# LAND OFF WEST MOOR CROFT ROAD, GOLDTHORPE (PHASE 3)

**Further Supplementary Ecological Information (SEI) including  
Revised Biodiversity Net Gain (BNG) assessment of land  
within New Park Springs**

Prepared for Gleeson Homes Limited

SLR Ref: 424.03044.00237  
Version No: 1  
August 2022

PROPOSED ECOLOGICAL  
ENHANCEMENTS  
TO 'NEW PARK SPRINGS'

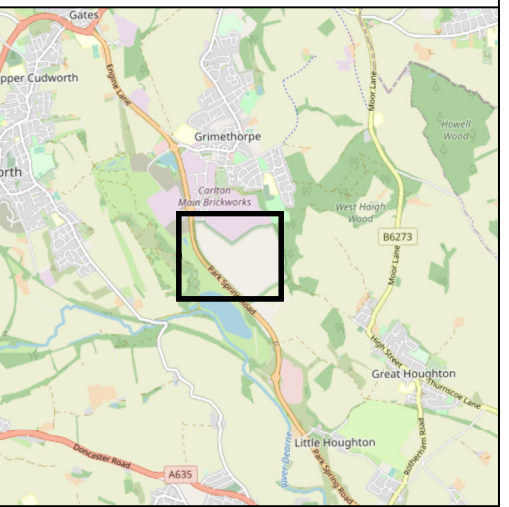
- Within the off-site habitat baseline tab, it is set out that areas of other coniferous woodland (0.49 ha) and other neutral grassland (0.412 ha) will be enhanced by converting these habitats to mixed scrub. As the proposed works represent a change in broad habitat types this would generally be considered as habitat creation rather than enhancement, therefore off-site baseline habitats should be assumed as lost and the replacement habitat added to the D2 off-site habitat creation tab. Refer to paragraph 4.84 and Box 5-3 of the Biodiversity Metric 3.0 User Guide.

- The trading rules of the metric have not been satisfied and this relates to the loss of medium distinctiveness habitats including bramble scrub and other neutral grassland, with habitat creation and enhancement measures proposed not fully compensating for these. I am not overly concerned by the loss of bramble scrub as this had been assessed as being of low condition; however, the trading summary indicates quite a loss of

*other neutral grassland. Consideration should be given to the alteration of off-site habitat enhancement measures proposed, to include further areas of enhanced other neutral grassland in the place of mixed scrub planting and locating such enhancement in association with the orchid translocation areas to provide larger enhanced areas.*

The remaining biodiversity units, required to off-set the shortfall, would be achieved by clearing an area of relatively dense but young coniferous woodland in 'poor' condition, and replacing this with mixed, native species-rich scrub. Having considered this further, it is accepted that this comprises habitat 'creation', rather than habitat 'enhancement', and Metric 3.1 has been completed to reflect this.

This will require the removal of 0.75ha of coniferous woodland, centred at OS grid reference SE 41215 07633, rather than the 0.49ha earmarked for removal in the previous metric calculation. The mixed scrub shall comprise the same species mix as proposed above for Scrub Planting Areas 1, 3 and 4, but with the addition of pedunculate oak (*Quercus robur*), which shall comprise 10% of the mix. Planting shall take place at 3m centres.

All of these enhancements/ area of habitat creation are illustrated in Drawing 1.
